Contribution towards P802.1ASdm/D0.3 Comment

resolution

The following text should be amended to form a new chapter 17.4.3.

Dual-Domain, Single-Source GrandMaster

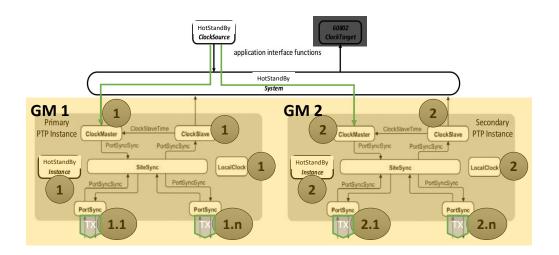
When both the primary and secondary PTP Instance are grandmaster (i.e., no external port in SlavePort state), the HotStandbySystem shall transfer phase and frequency from the HotStandbyClockSource to both the ClockMaster of the primary and secondary PTP Instances. The phase and frequency are transferred using the ClockSourceTime interface, but with the modification that the ClockSourceTime.invoke function is received by the HotStandbySystem entity from the HotStandbyClockSource entity and sent to the ClockMaster entity of both PTP Instances.

No ClockTarget Application is present in this device.

Single-Domain, Network-Source GrandMaster Bridge

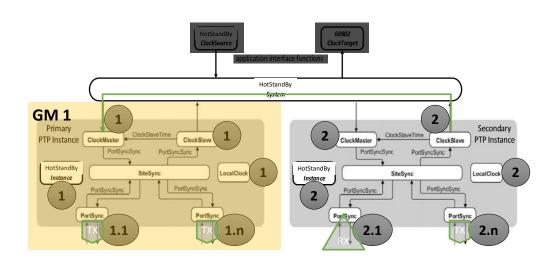
When any single one PTP Instance is grandmaster (i.e., no external port in SlavePort state), the HotStandbySystem shall transfer phase and frequency from the ClockSlave of the other PTP Instance to the ClockMaster of the PTP Instance acting as GrandMaster.

No ClockSource or ClockTarget Application is present in this device.

Combined Single-Domain, Network-Source GrandMaster Bridge + Target (Slave)

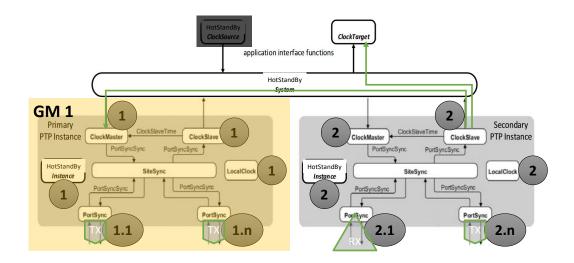
When any single one PTP Instance is grandmaster (i.e., no external port in SlavePort state) and an application layer ClockTarget is present, the HotStandbySystem shall transfer phase and frequency from the ClockSlave of the other PTP Instance to the ClockMaster of the PTP Instance acting as GrandMaster as well as to the ClockTarget.

No ClockSource Application is present in this device.

Dual-Domain, Network -Source Bridge

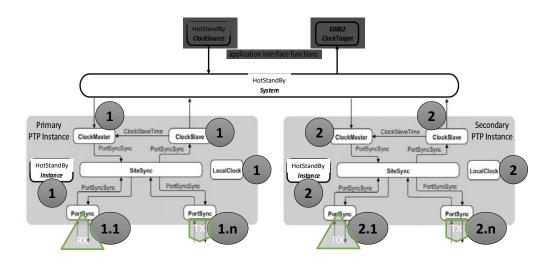
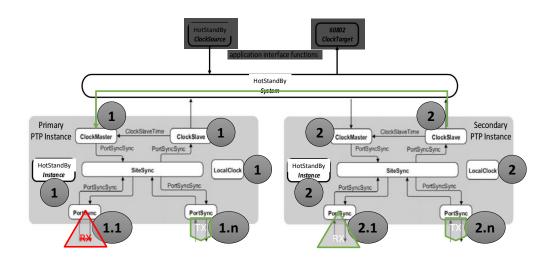
No ClockSource or ClockTarget Application is present in this device.

When no PTP Instance is grandmaster (i.e., both have external ports in SlavePort state), the HotStandbySystem shall be prepared to transfer phase and frequency from the ClockSlave of the other PTP Instance still synchronized to the ClockMaster of the PTP Instance that has lost it's synchronisation.

Combined Dual-Domain, Network-Source Bridge + Target (Slave)

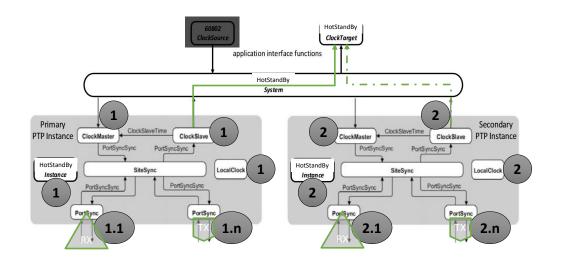
When no PTP Instance is grandmaster (i.e., both have external ports in SlavePort state), the HotStandbySystem shall transfer phase and frequency from the ClockSlave of at least one PTP Instance to the (HotStandby-)ClockTarget

Better would be if the HotStandbySystem could be configured transfer phase and frequency from both PTP Instances to the HotStandby-ClockTarget for comparison.

No ClockSource Application is present in this device.

When no PTP Instance is grandmaster (i.e., both have external ports in SlavePort state), the HotStandbySystem shall be prepared to transfer phase and frequency from the ClockSlave of the PTP Instance still synchronized to the ClockMaster of the PTP Instance that has lost it's synchronisation as well as to the ClockTarget.
